CITY OF ALBUQUERQUE

Re: Maher Warehouse, 4120 Culter Ave. NE, Grading and Drainage Plan
Engineer's Stamp dated 05-16-08 (H-17/D086A)

Re: Maher Warehouse, 4120 Culter Ave. NE, Grading and Drainage Plan
Engineer's Stamp dated 04-16-08 (H-17/D086A)

Based upon the information provided in your submittal received 10-30-15, the above referenced plan cannot be approved for Building Permit until the following comments are addressed:

SHEET
TCL
1 OF 1

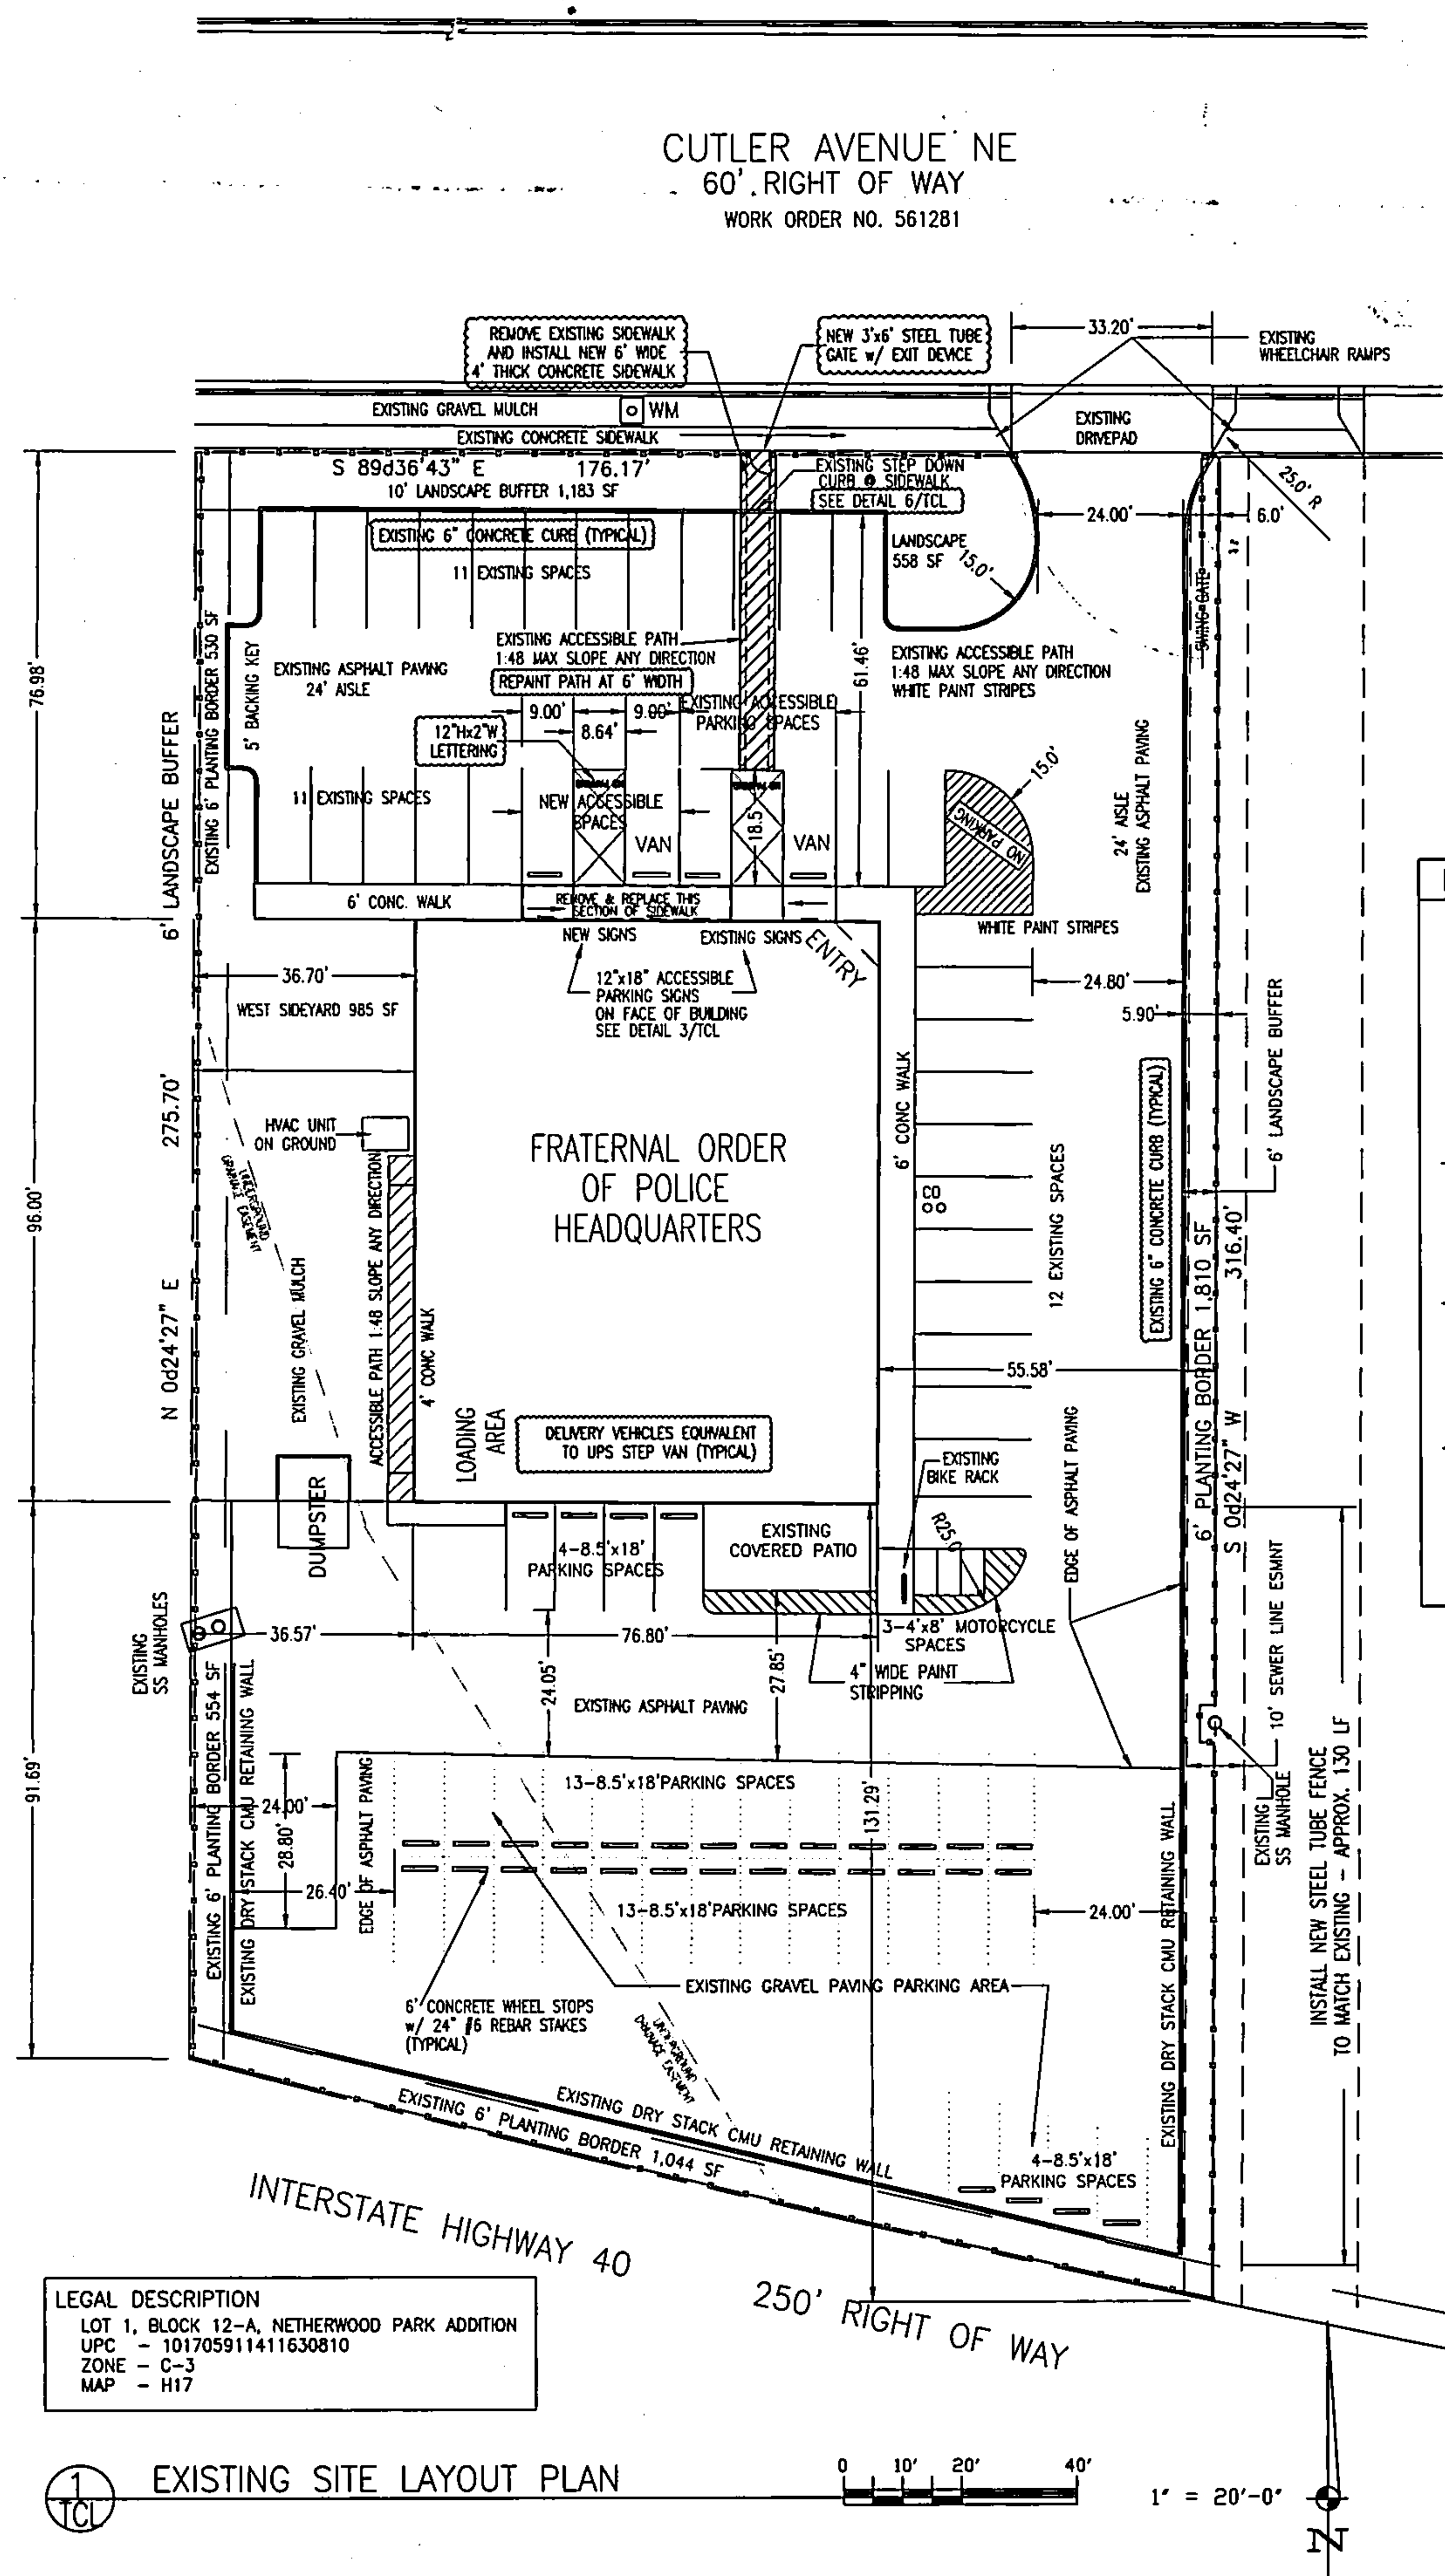
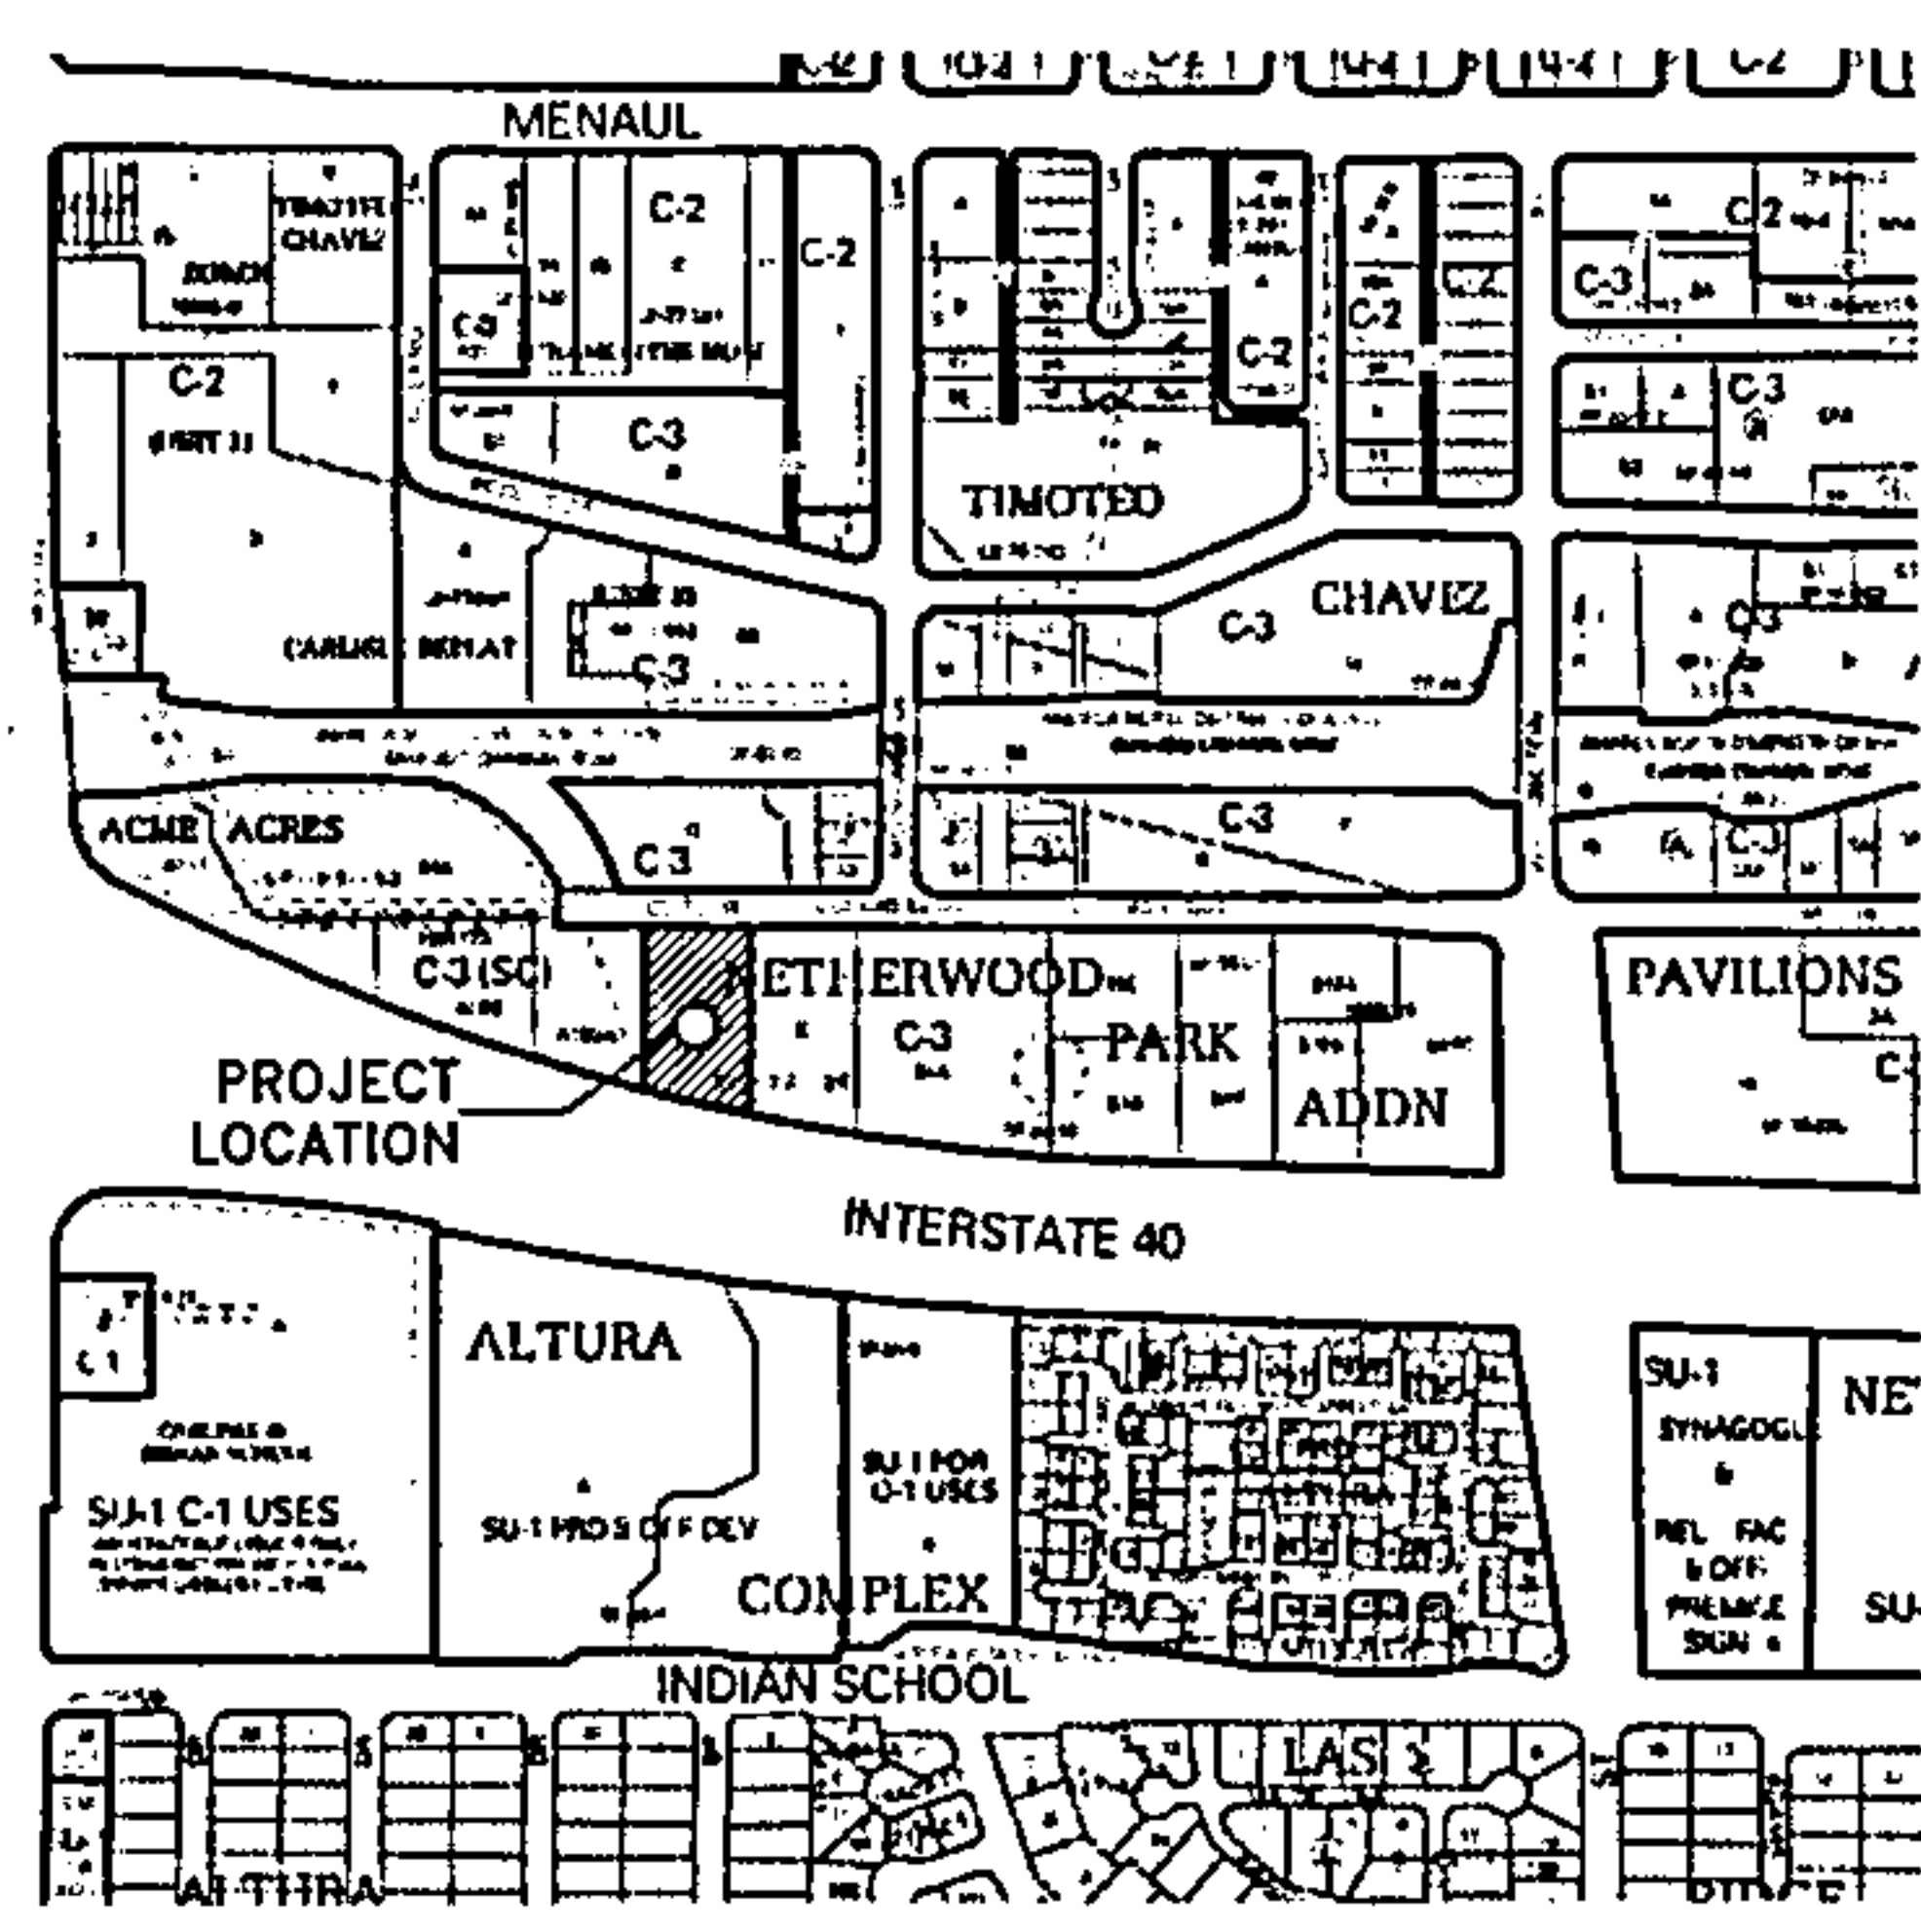
Mr. Clark, I noticed that you are putting Revision dates on the drawing dated 8-6-15. We need your final TCL Submittal Drawing with an updated Engr. Stamp date. Please resend the TCL BP Submittal drawing, along with the detail drawings with an updated Stamp date so that I may complete the TCL BP approval for your project.

Can you send me a detail of this to add to the drawing and please state the slope. Formalize the detail drawing, referencing the detail to the original drawing.

Gary:
Attached are two files:
1524D-Detail 6-TCL 8 1/2x11 format of the Step Down Curb Detail to add to the drawing;
and
1524D-TCL-12Nov15 24x36 format TCL Plan Sheet showing the Detail 6 and a callout note on the step down curb on the north edge of the parking area to supplant the 10 Nov 15 PDF file previously submitted.
Thank you,
Jim
